UNITED STATES STEEL CORPORATION
DESIGN ENGINEERING - PITTSBURGH
225 GULF BUILDING
PITTSBURGH, PENNSYLVANIA 15230

ADDENDUM

SPECIFICATION NO. 535-4102-62-ADD. 1

INSULATION FOR PIPING AND EQUIPMENT
KEYSTONE PROJECT

PIPING-SCHEMATIC AND
 HOT WATER HEATER LOCATION
 CONTROL ROOM #1 - AREA VI
 KEYSTONE PROJECT-CLARKTON WORKS

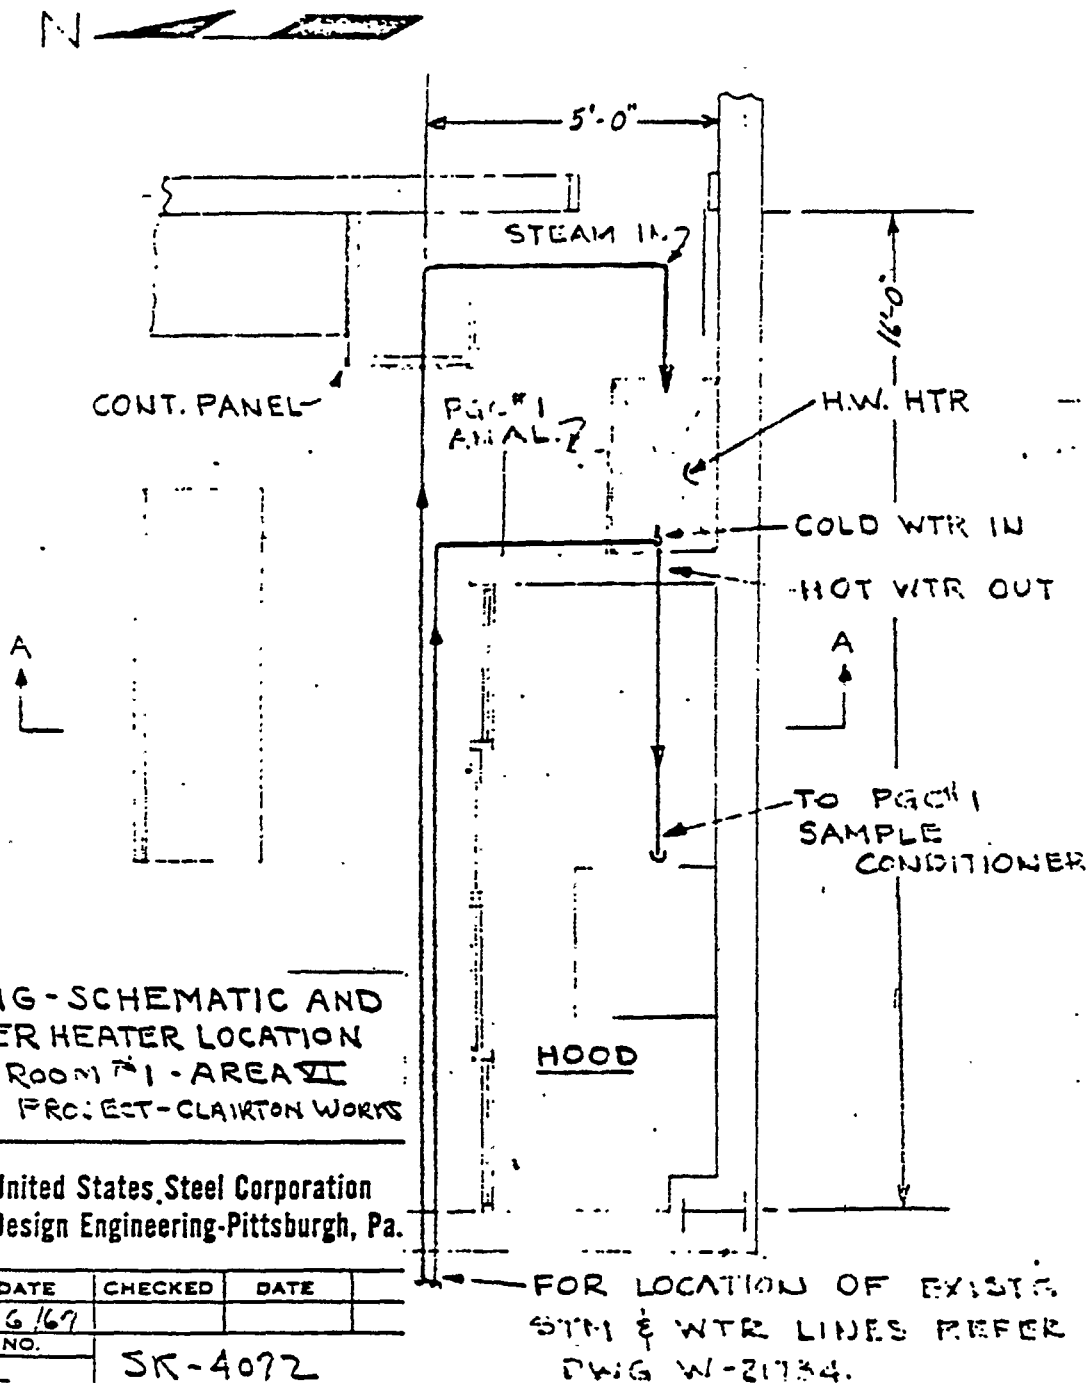
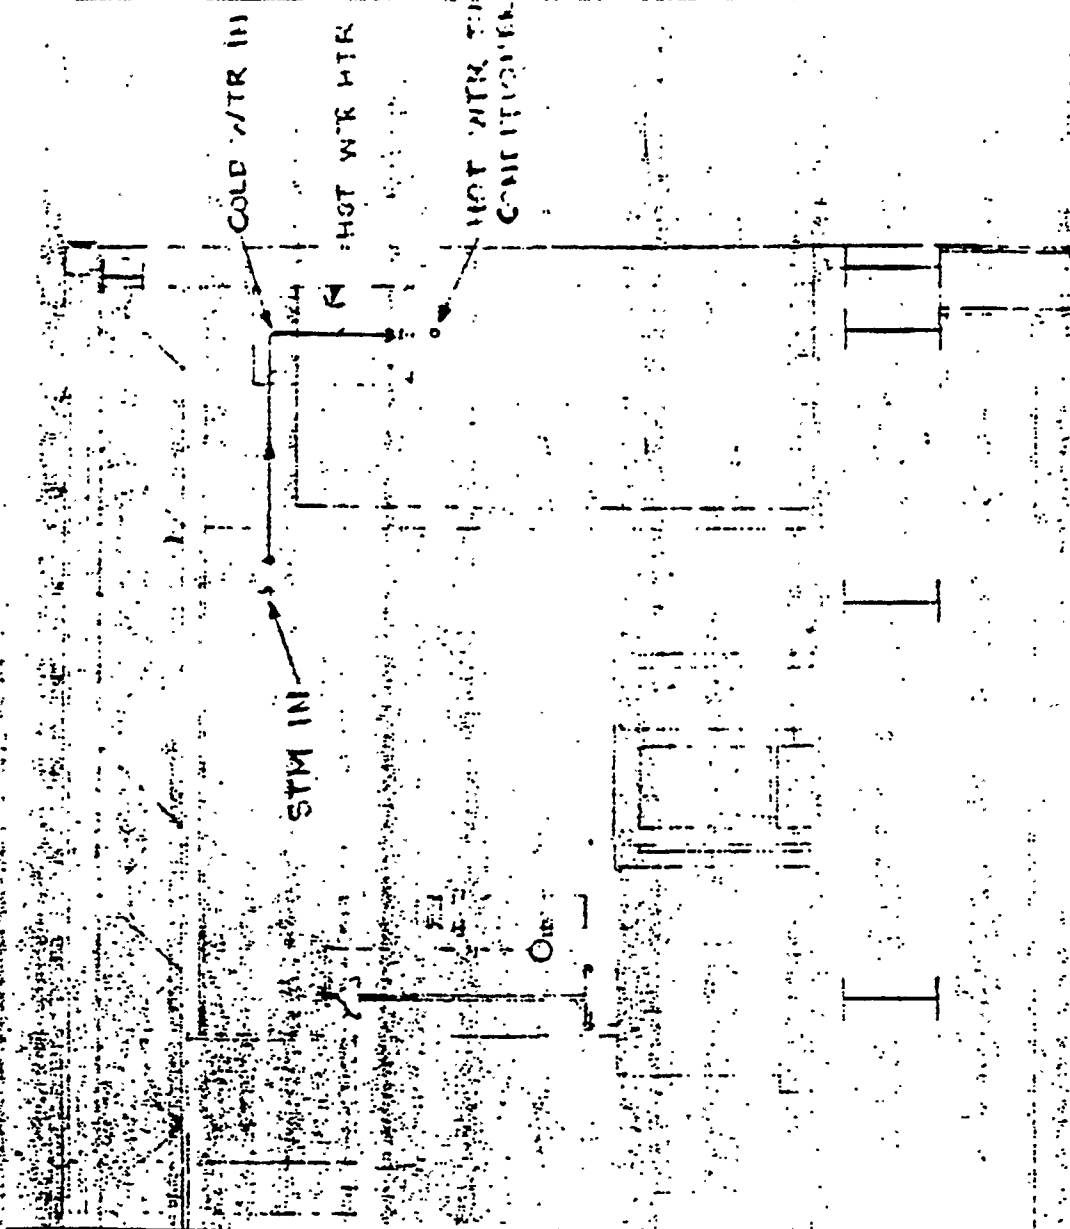
- 3.21 Contractor shall insulate the 30-gallon per minute Constantemp hot water heater system, Model B-321, manufactured by the Leslie Company of Lynhurst, New Jersey, located in No. 1 Control Room, in accordance with Insulation Specification INS-III. Insulate areas as indicated on Drawing No. W-21037, Revision 0, dated March 8, 1967, entitled "Piping - Schematic Control Room No. 1 Hot Water Tracer - Keystone Project - Area 6 - Clairton Works". Attached Sketches No. 4072, Pages 1 and 2, entitled "Piping - Schematic and Hot Water Heater Location. Control Room No. 1. Area VI" will furnish additional information. This will include supply lines, location of heater and discharge line.

AMMONIA FRACTIONATOR
T-350 & T-358

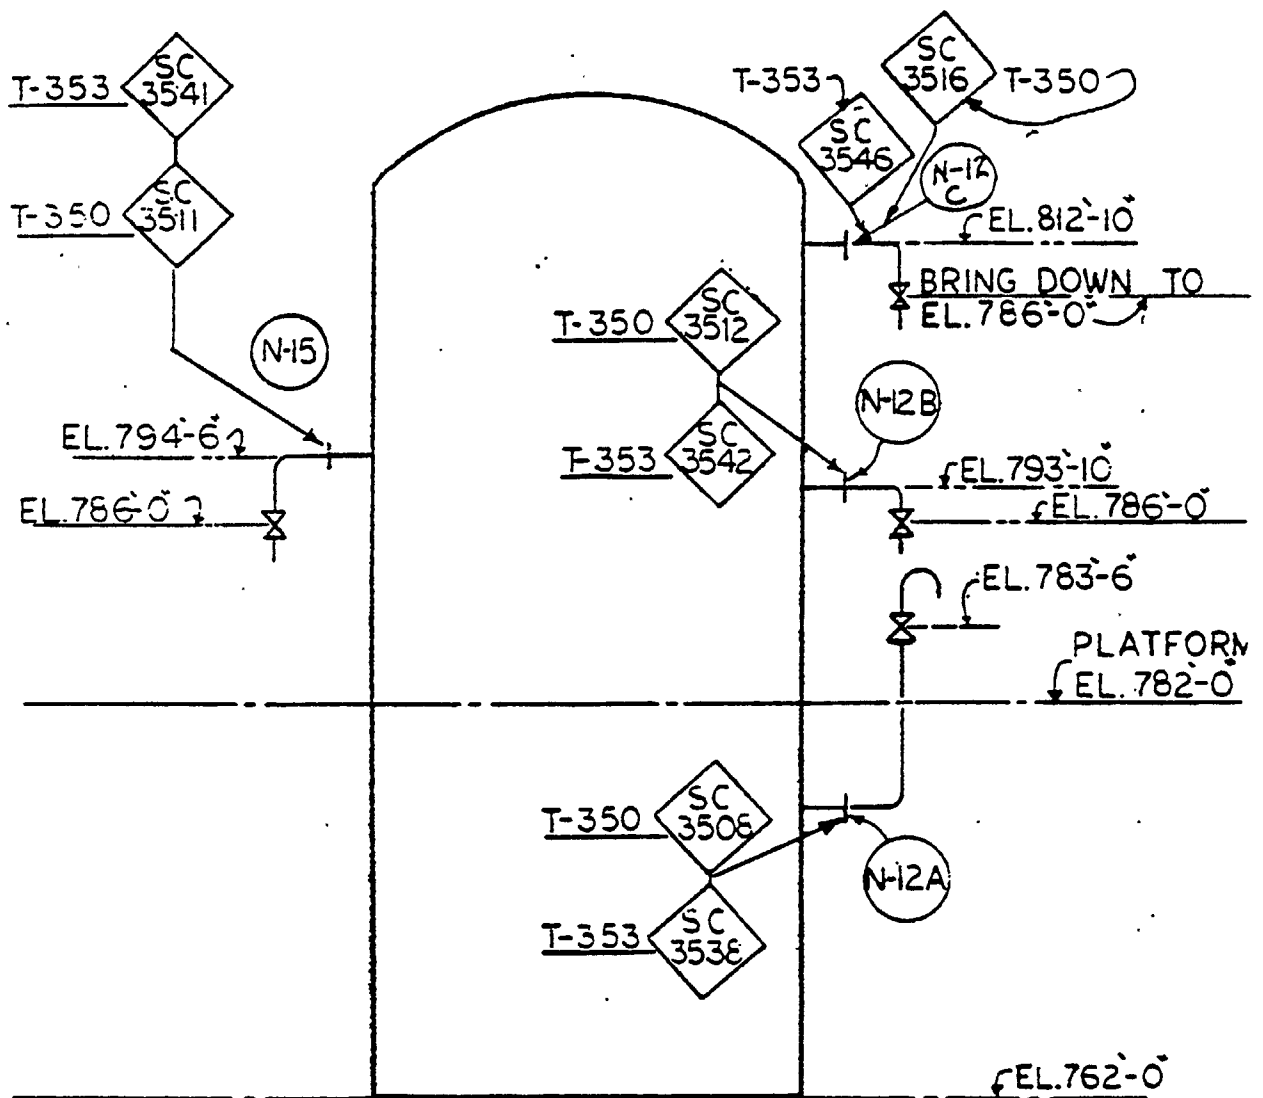
SC No.	Drawing No.	Revision No.	Line Temperature	Size	Protection	Extent of Insulation
3541	*C 8487 Sh. 1B	B	215 F.	1/2"		See Sketch No. 2 Insulate from disch. as specified for personnel protection
3542	*C 8487 Sh. 1B	B	215 F.	1/2"		See Sketch No. 2 Insulate from disch. as specified for personnel protection
3546	*C 8487 Sh. 1B	B	215 F.	1/2"		See Sketch No. 2 Insulate from disch. as specified for personnel protection
3401	W-21996	3	200° F.	1/2"		Insulate from disch. 4' 0" above 752'-0" to 762'-0" Sec. "CB-CB"
3411	W-21996	3	200° F.	1/2"		Insulate from disch. 4'-0" above 762'-0" to 772'-0" Sec. "CB-CB"

AMMONIA STRIPPER COLUMN T-306 & T-307 INSTALLATION
OF SAMPLE CONNECTIONS

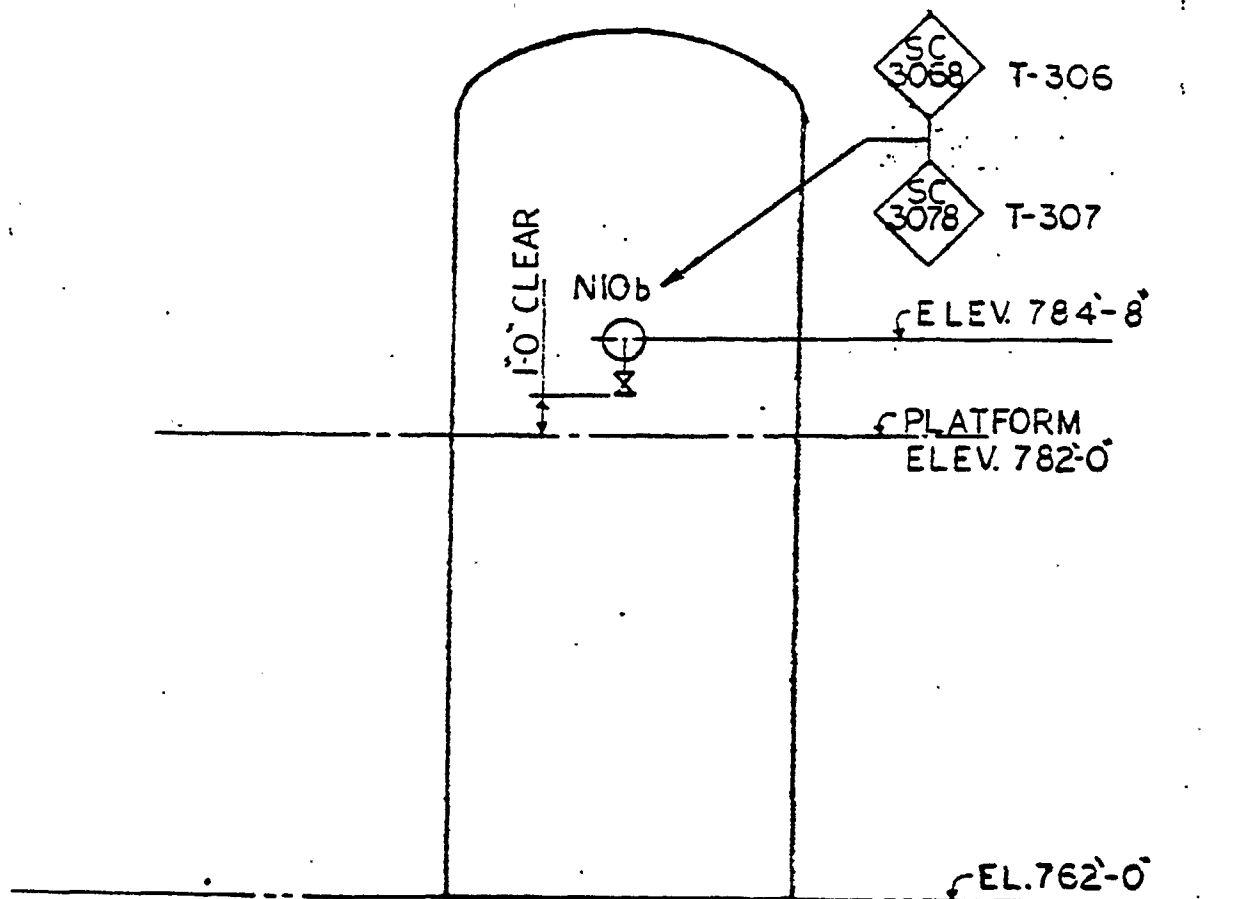
3068	*C-8488 Sh. 101	F	370° F.	1 1/2"		See Sketch No. 1 - Insulate from conn. to disch.
3078	*C-8488 Sh. 101	F	370° F.	1 1/2"		See Sketch No. 1 - Insulate from conn. to disch.
3382	W-21994	4	253° F.	1 1/2"		Insulate from conn. to disch. 2'-0" above floor 762'-0" - Sec. "N-N"
3392	W-21994	4	183° F.	1 1/2"		Insulate from conn. to disch. 2'-0" above floor 762'-0" - Sec. "N-N"
3508	*C-8487 Sh. 1AB	3	393° F.	1 1/2"		See Sketch No. 2 - Insulate from conn. to disch. 1'-0" above platform elev. 782'-0"
3511	*C-8487 Sh. 1B	E	393° F.	1 1/2"		See Sketch No. 2 - Insulate from disch. as specified for personnel protection
3512	*C-8487 Sh. 1B	B	393° F.	1 1/2"		See Sketch No. 2 - Insulate from disch. as specified for personnel protection
3516	*C-8487 Sh. 1B	B	215° F.	1 1/2"		See Sketch No. 2 - Insulate from disch. as specified for personnel protection
3538	*C-8487 Sh. 1AB	B	215° F.	1 1/2"		See Sketch No. 2 - Insulate from conn. to disch. 1'-0" above platform elev. 782'-0"

MODEL NO. 12720, 12721, 12722, 12723, 12724, 12725, 12726, 12727, 12728, 12729, 12730	
LIQUID LEVEL TRANSMITTER	
12000 SERIES	
12720, 12721, 12722, 12723, 12724, 12725, 12726, 12727, 12728, 12729, 12730	
DATE	11-10-63
BY	CP10-1-1
1

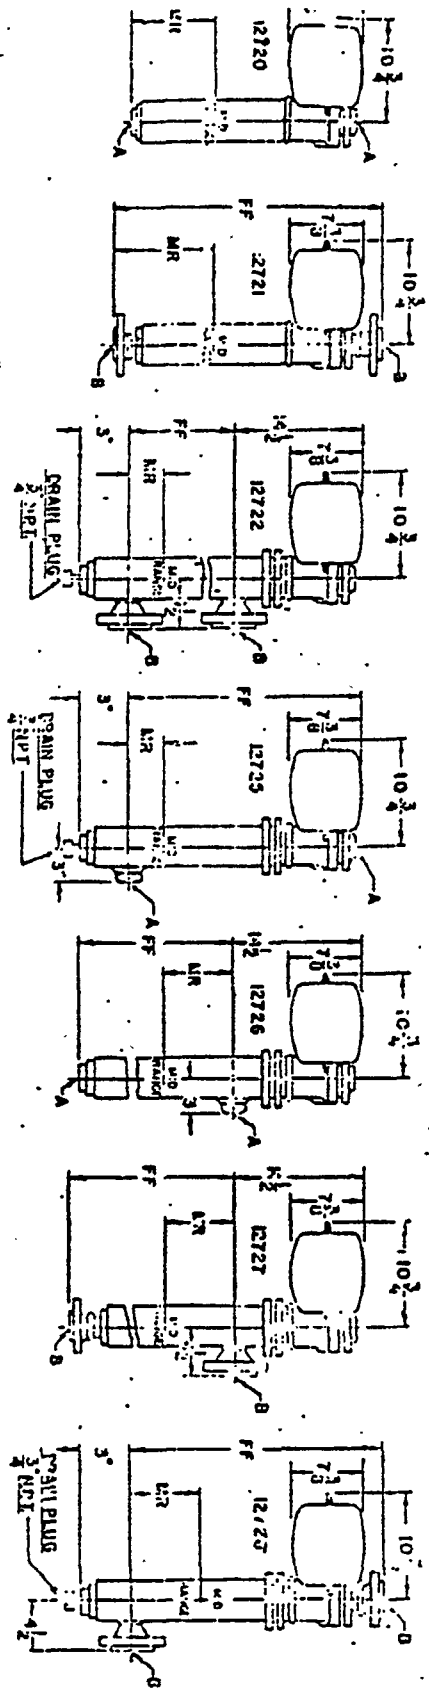
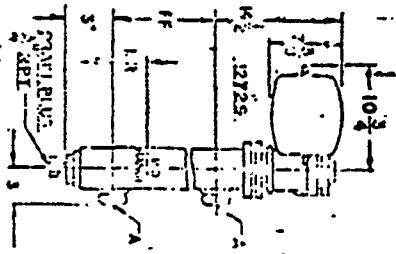
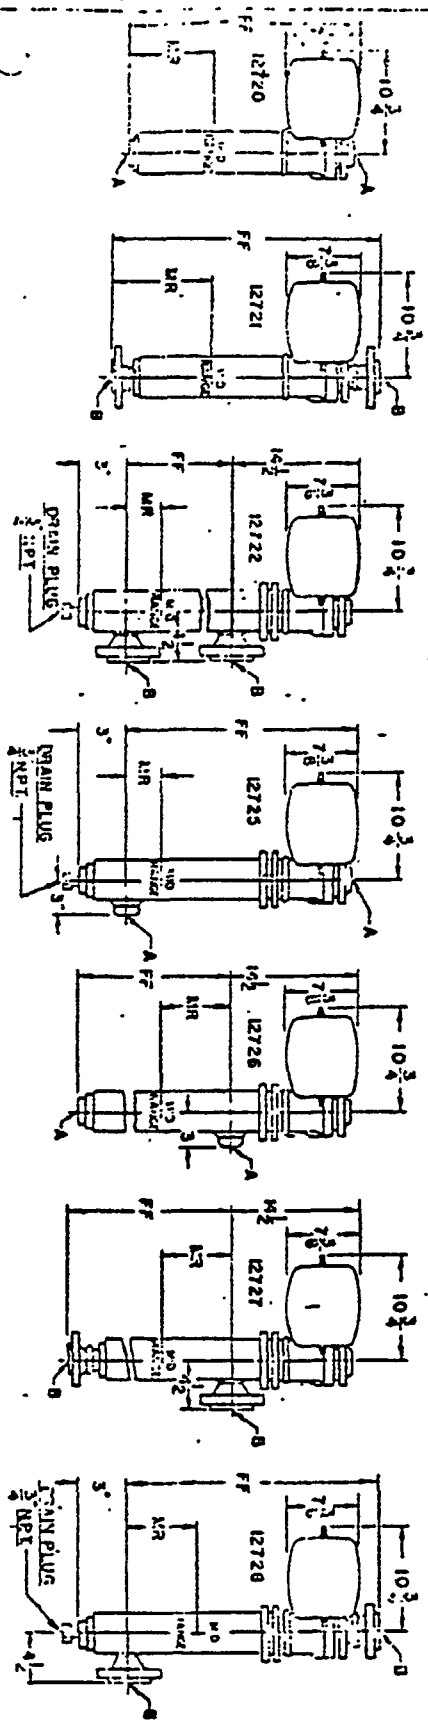
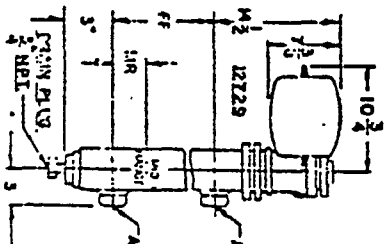
- 3.32 Furnish all supervision, labor, materials, tools, equipment and incidentals necessary to insulate ten (10) liquid level transmitters shown on the attached Drawing No. CP10-1-1-C; subject transmitters are located in Area VII-B.

LIC-6141-A
LIC-6114-A
LIC-6023-A
LIC-6005-A
LIC-6092-A
LIC-9319-A
LIC-6083-A
LIC-5730-A
LIC-6243-A
LIC-5753-A

5.1.5 Items described in Paragraphs 3.32 and 3.33 of this Addendum shall be insulated in accordance with applicable sections of INS-3 (hot insulation). All insulation shall be one (1) inch thick.

ELECTRONIC TRANSMITTERS

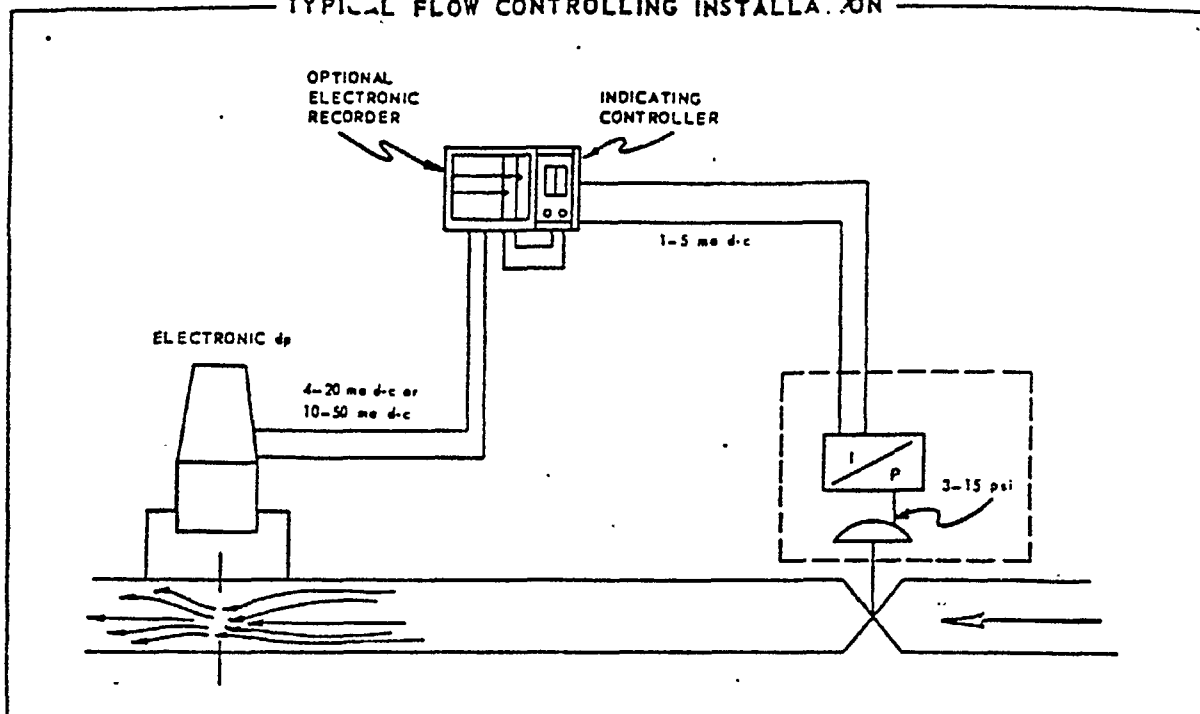
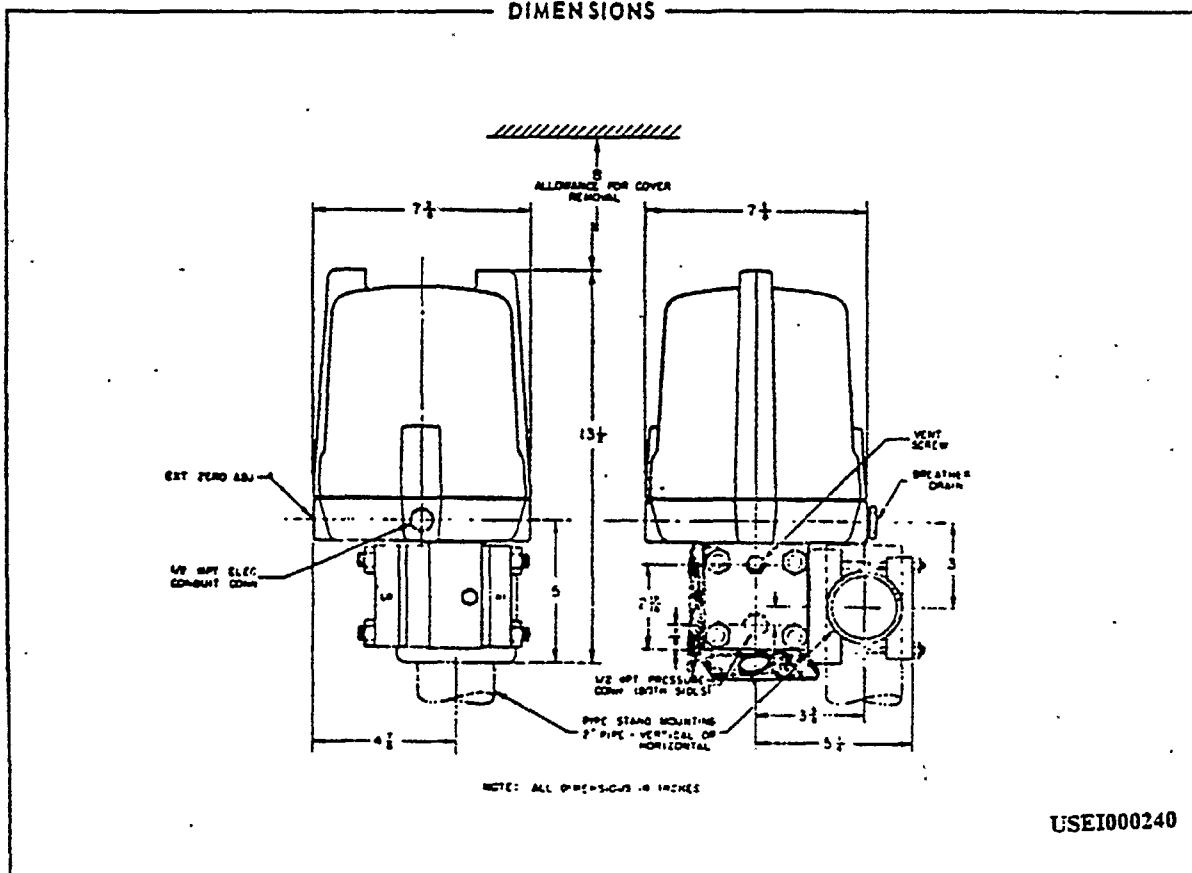
- 3.33 Furnish all supervision, labor, materials, tools, equipment and incidentals necessary to insulate approximately twenty-five (25) steam-traced liquid sections of electronic transmitters as shown on attached Drawing No. SK-1.
